<b>PROJECT:</b>	Villa's at Gardner Rd. Village of Horseheads Municipal Construction Inspection December 5, 2018
<b>BY:</b>	Jessica Verrigni, CPESC, CPSWQ

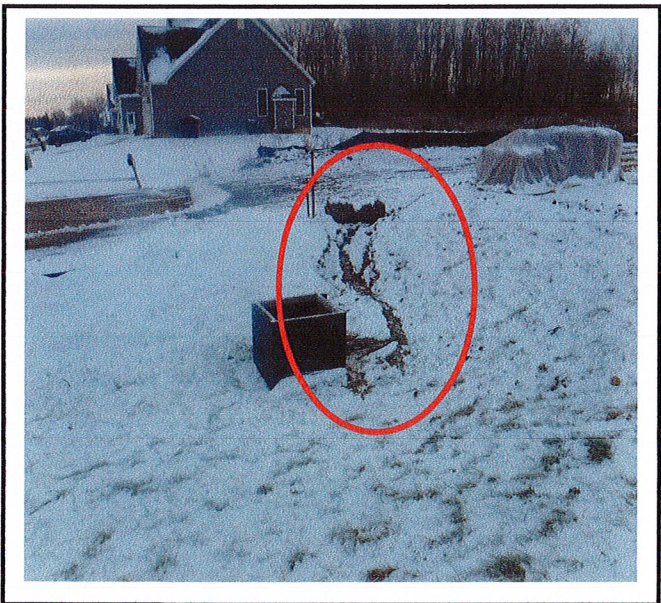
Pavement has been completed since the last municipal inspection.

Center island has not been stabilized.

Channel erosion is occurring into the stormwater forebay.- no correction has been made.

Erosion into CB3 is still occurring and no correction has been made.
